SERVICE BULLETIN

SERVICE BULLETIN NO. 303

SEPTEMBER 2002

3059 Kodak X-Omat 270 RA PROCESSOR
3291 Kodak X-Omat 270 RA INTEGRATED PROCESSOR
3434 Kodak X-Omat 3000 RA PROCESSOR
3511 Kodak X-Omat 3000 RA INTEGRATED PROCESSOR
3466 Kodak X-Omat 3000 RA INTEGRATED PROCESSOR
3227 Kodak X-Omat 180 LP PROCESSOR
3198 Kodak X-Omat 180 LPS PROCESSOR
3482 Kodak X-Omat 1000 PROCESSOR

Checking ECCENTRIC CAM on REPLENISHMENT PUMP 1C4593

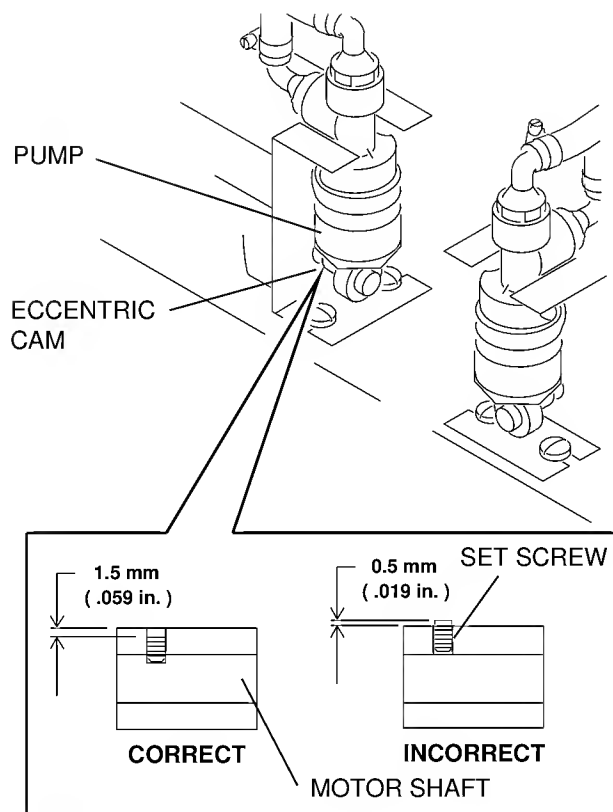
On some of the REPLENISHMENT PUMPS, the SET SCREW that holds the ECCENTRIC CAM in place on the MOTOR SHAFT was incorrectly assembled. If the PUMPS were incorrectly assembled, there is a high risk that the ECCENTRIC CAM may slip on the SHAFT, resulting in no replenishment when the PUMP runs. This condition may result in a user complaint of the sensitometry going out of control, caused by lack of developer replenishment, or improper clearing or washing of the film, caused by lack of fixer replenishment.

When correctly assembled, the SET SCREW is designed to tighten into a hole on the MOTOR SHAFT. On the PUMPS that were incorrectly assembled, the SET SCREW was not aligned with the hole, and was tightened directly onto the SHAFT.

If you have a problem with the ECCENTRIC CAM slipping on the MOTOR SHAFT, just tightening the SET SCREW will not permanently fix the problem, it will probably start to slip again in a short period of time if it isn't tightened into the hole in the shaft.

It is recommended that you do the following simple visual check at your next site visit, or on any REPLENISHMENT PUMPS you may have in stock:

H127_0258GCA
H127_0258GC

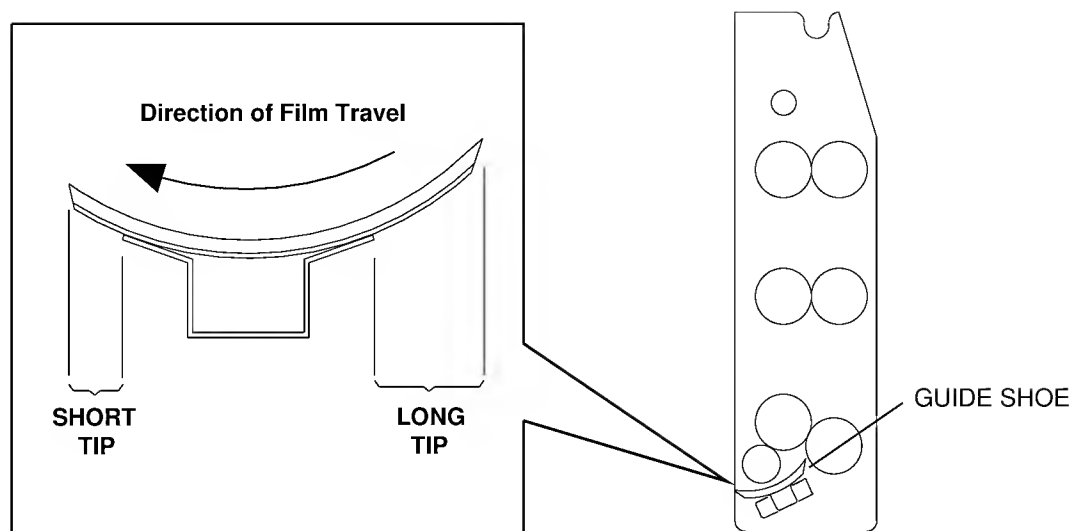
On **correctly** assembled PUMPS, the top of the SET SCREW will be approximately 1.5 mm (.059 in.) below the top of the screw hole.

On **incorrectly** assembled PUMPS, the top of the SET SCREW will be approximately 0.5 mm (.019 in.) above the top of the screw hole.

If the PUMP is found to be incorrectly assembled, do the following:

- Remove the SET SCREW, and rotate the ECCENTRIC CAM on the MOTOR SHAFT to line up the SET SCREW hole with the hole on the MOTOR SHAFT.
- Install the SET SCREW in the ECCENTRIC CAM and tighten the SET SCREW into the screw hole.
